NRC DOCKETS 50-321, 50-366
OPERATING LICENSES DPR-57, NPF-5
EDWIN I. HATCH NUCLEAR PLANT UNITS 1, 2
NRC I&E BULLETIN 80-11

NRC I&E BULLETIN 80-11, "MASONRY WALL DESIGN"

RESPONSE TO NRC REQUEST FOR
ADDITIONAL INFORMATION

EDWIN I. HATCH NUCLEAR PLANT

Project	HATCH-UNIT 110, 1 & 2	Prepared By	TINA C. SALSER	Date	11-21-80
Subject/Title	WALL MODIFICATION	Reviewed By	K.L. WITHERS	Date	11-25-80
C-130-7A & 7B (P50C-80-007)		Calculation Number		Sheet	4 of 8

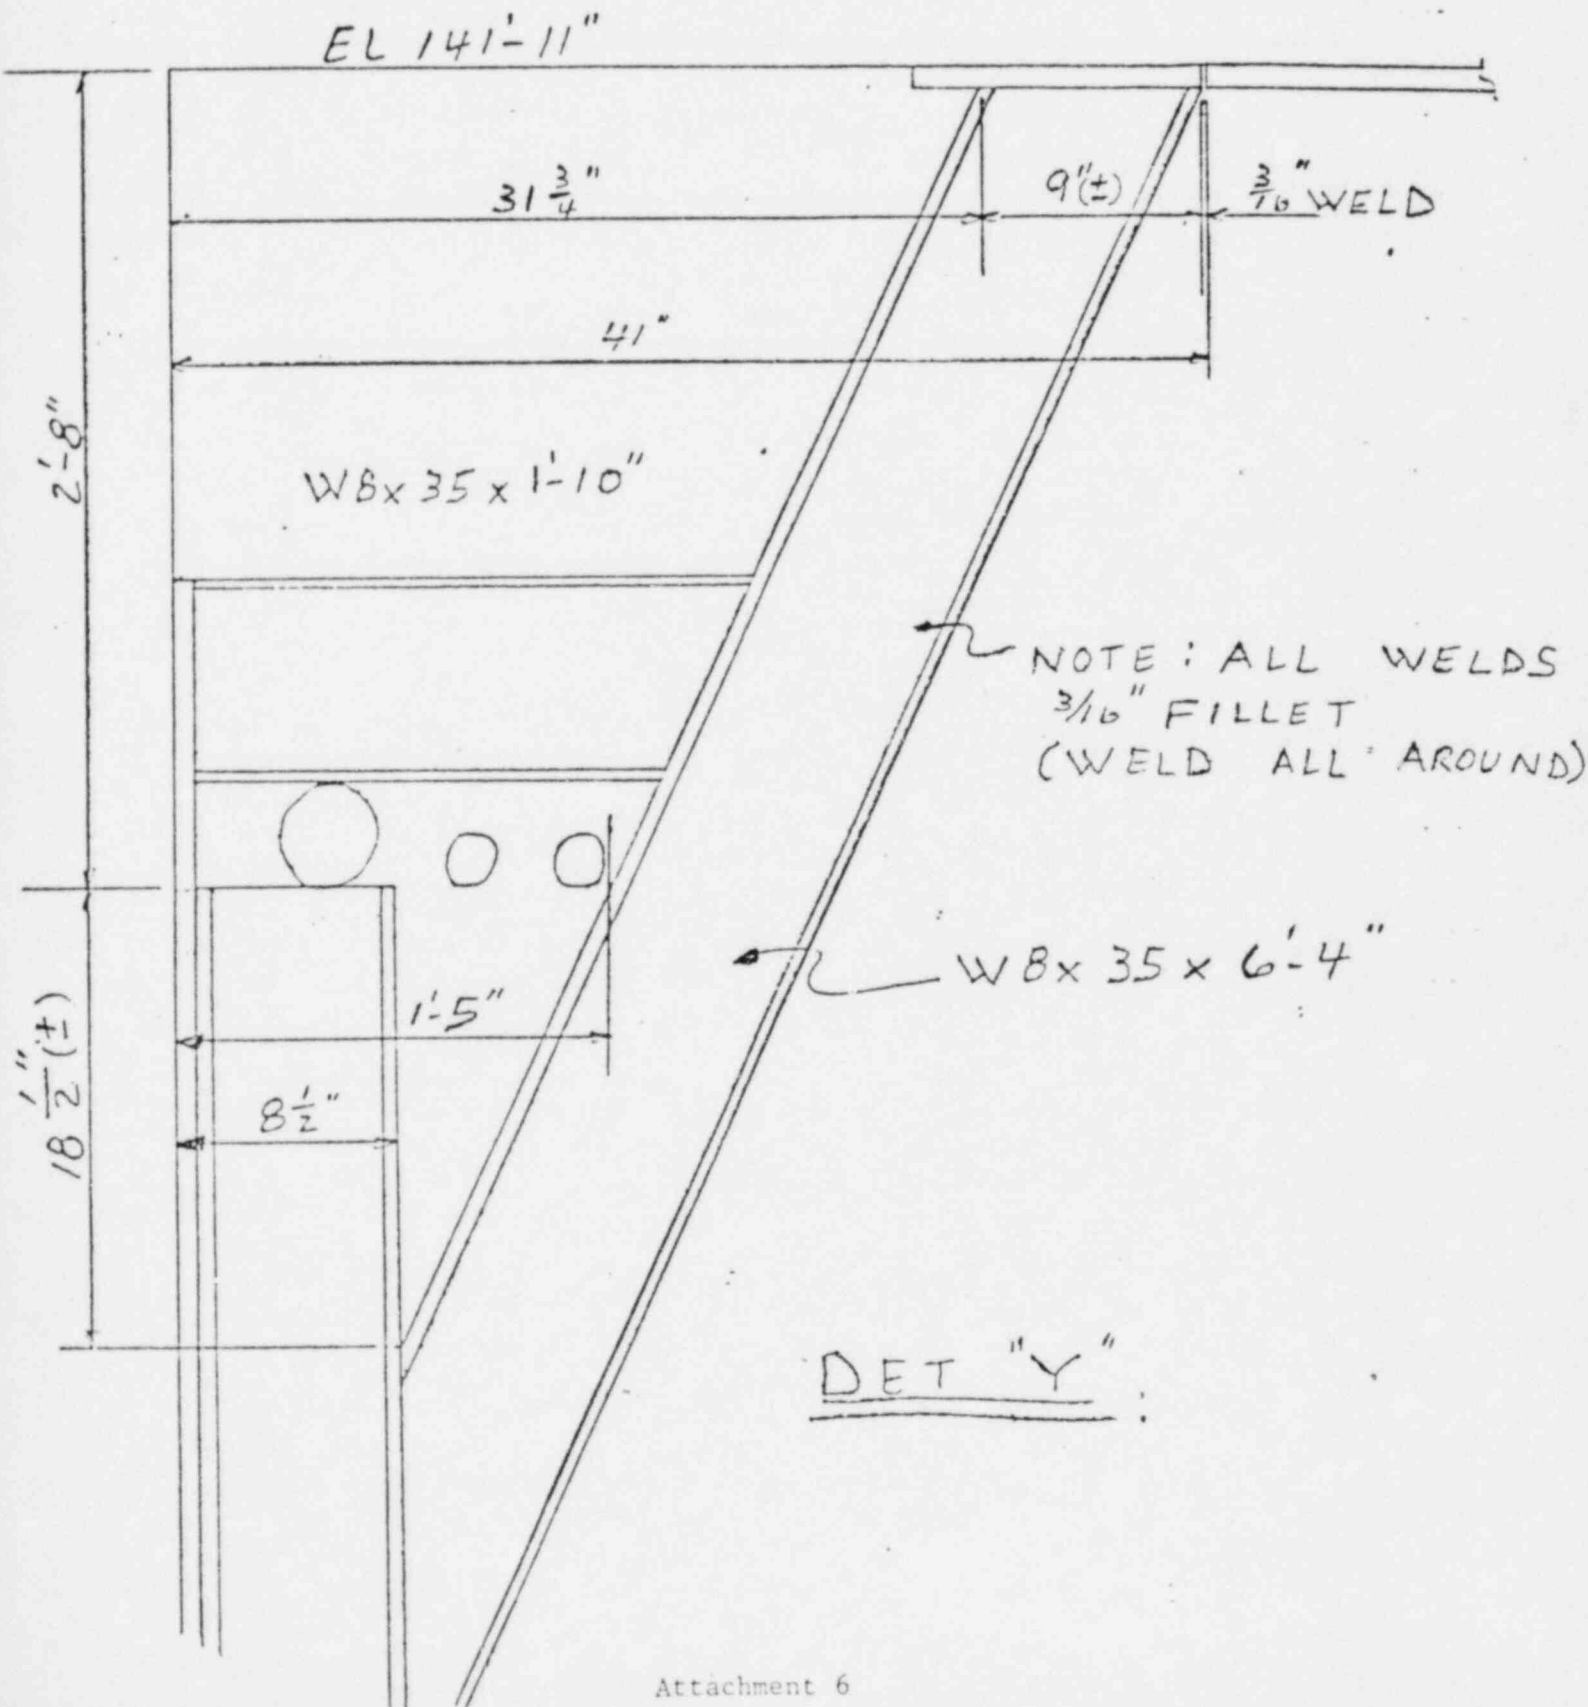
Provide details of modifications for all walls that do not satisfy the design allowables. Technical discussion should be provided detailing how these modifications will correct this deficiency. Also, provide the modification schedule.

A number of walls were modeled for STRUDL-DYNAL and had a finite element analysis run of the as-built condition, taking into account all loads and load combinations. A total of ten (10) walls were identified where calculated stresses exceeded allowable stresses. The results of the analysis showed that the effective horizontal span length of the wall should be reduced. Therefore, a point somewhere within the middle one-third of the span of the wall was chosen considering obstructions and installation problems, and one or more structural steel columns were erected to provide additional support for the wall. The column(s) were designed to withstand the applied loads and were used to brace the wall as shown in the attached sketches. The wall was then re-modeled for STRUDL-DYNAL, including the steel column, and a finite element analysis was performed again for all postulated loads and load combinations. Resulting moments and shears for the masonry wall and support column were checked against allowables. In addition, bolts, plates, and welds for the support having an angle brace were checked for worst-case loads. Wall number C130-14A&B had an angle brace attached to the ceiling on each side of the wall to provide lateral shear support and reduce a local overstress condition to within allowables. Following the analysis using the modified models, each wall was determined to satisfy all stress allowables.

Detailed sketches of the modification for each wall are shown in attachments 1 through 8. The field modifications for each wall are complete except for wall C164-4A&B and wall C130-39A&B. Both of these walls will be removed in the near future to allow for relocation of the shift supervisors office and modifications in the health physics area. Therefore, no modifications have been scheduled for these walls.

A. FINITE ELEMENT MODELS

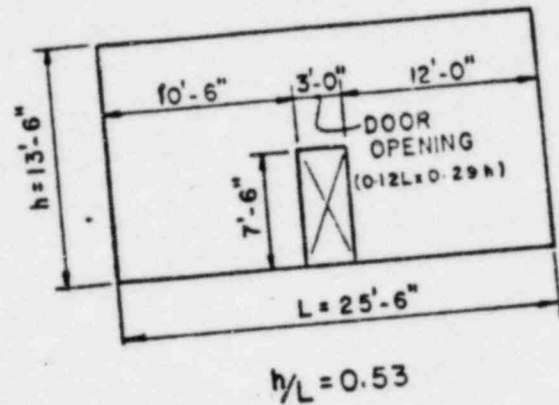
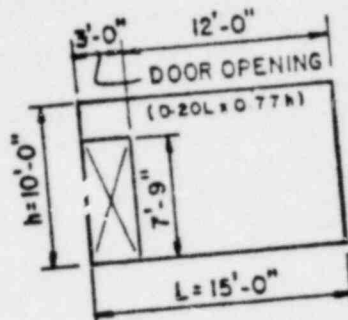
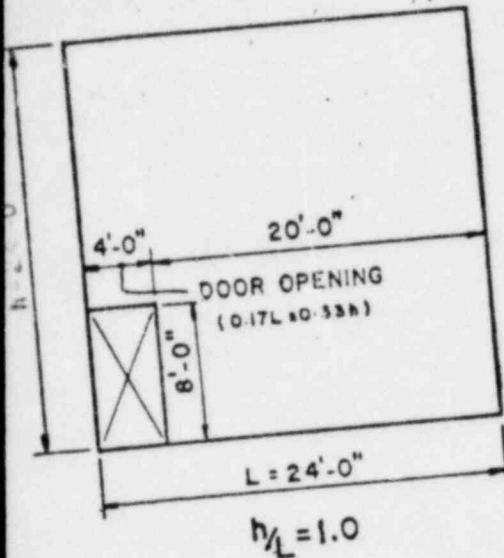
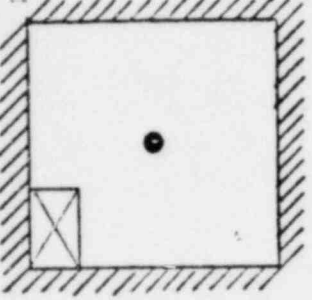
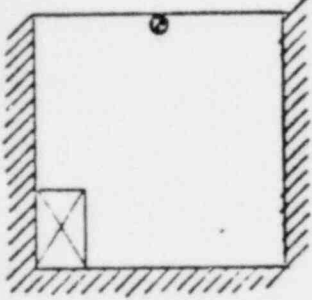
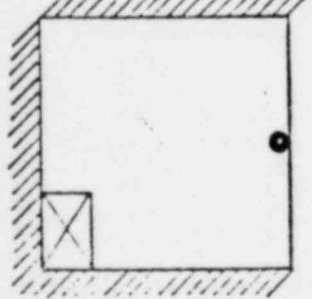
With respect to modes of vibration, Section 5.2.2 of Reference 2 indicated that the first mode of vibration accounts for over 99% of the total moment and displacement of the walls. Provide sample calculations (with different boundary conditions) to justify this position.

A committee was formed on August 5, 1980 by a number of utilities and Engineering firms to investigate concrete masonry analysis techniques. The committee was charged with the responsibility of investigating a number of factors affecting the analysis of concrete masonry walls including the effects of the participation of higher modes than the first on moments, shears, and displacements.

The Committee conducted a parametric study to determine the effect of the participation of higher modes. For each of the three boundary conditions referenced in Exhibit A, and for a cantilevered wall with an aspect ratio equal to 1.0, the modal displacements for the first eight modes were compared to the SRSS displacement for wall panels with the full $E_m I$ (D) and a reduced $E_m I$ (D) within the third segment of the panels. The results are tabulated in Exhibit B.1 and indicate that 99% of the displacement is contributed by the first mode. In addition to considering displacement, the committee reviewed the effect of modal participation on moments for the wall panels indicated in Exhibit B.2. It was again demonstrated that the first mode moment calibrated more than 99% of the SRSS moment for an eight mode analysis. For both the displacement and the moment study, an acceleration of $1.0g$ applied over the entire frequency range was used as the input spectra.

The finite element program used did not provide shear values within the elements nor at the supports. It is the Committee's opinion, however, that the first mode would likewise contribute at least 99% of the shear in wall and at the supports since the wall moment (99% contribution from the first mode) is derived from the shear diagram.
